Access Compliance Report

Public Rights-of-Way

(Curb Ramps)

Intersection ID: 15457	Main Street: EAST_BV	Cross Street: LOMBARDY_CR	Location: SW
ADA ID: 5503E6A4B4B8	Ramp Type: Perp	Initial Pass/Fail: Fail	Overall Compliance: No
Severity Score: 35			
Codes/Mitigation Info/Possible Solution		Field Measurements/Component Compliance

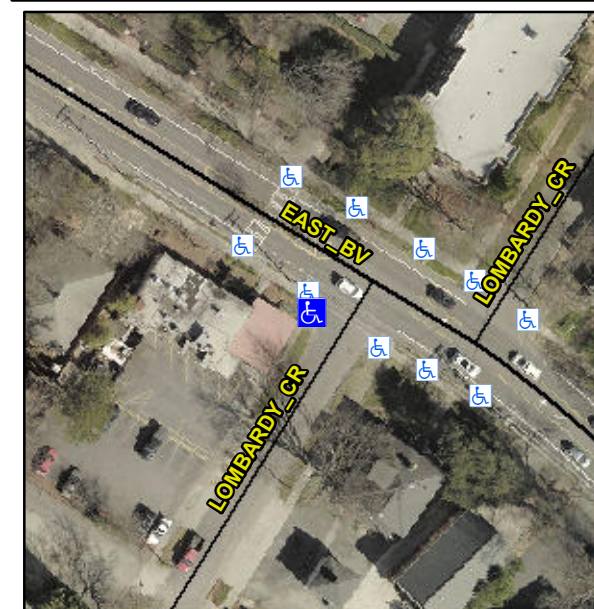
Not Found, R304.5.1, R304.2.2, R304.5.3

Compliance	Description	Data	Compliance	Description	Data
N/A	Ramp Length (in)	40.0	No	Ramp Slope (%)	15.3
No	Ramp Width (in)	37.0	No	Ramp XSlope (%)	3.4
N/A	Flare Type LT	N/A	N/A	Flare Type RT	N/A
N/A	Flare Slope LT (%)	N/A	N/A	Flare Slope RT (%)	N/A
N/A	Flare Traversable LT?	N/A	N/A	Flare Traversable RT?	N/A
N/A	Landing Length (in)	N/A	N/A	DWS Provided?	N/A
N/A	Landing Width (in)	N/A	N/A	DWS Contrast?	N/A
N/A	Landing Slope (%)	N/A	N/A	DWS Length (in)	N/A
N/A	Landing X Slope (%)	N/A	N/A	DWS Full Width?	N/A
N/A	Landing Curb? (Y/N)	N/A	N/A	DWS Offset (in)	N/A
N/A	Shared Landing?	N/A			
N/A	Gutter Ponding?	N/A	N/A	Gutter Slope (%)	N/A
N/A	Gutter Lip Ht (in)	N/A	N/A	Gutter X Slope (%)	N/A
N/A	Painted X Walk1?	No	N/A	Painted X Walk2?	N/A
	X Walk 1 Direction	To SE		X Walk 2 Direction	N/A
N/A	X Walk 1 Width (in)	N/A	N/A	X Walk 2 Width (in)	N/A
	X Walk 1 Slope (%)	2.4		X Walk 2 Slope (%)	N/A
	X Walk 1 X Slope (%)	1.7		X Walk 2 X Slope (%)	N/A

Remove & Replace Entire Ramp.
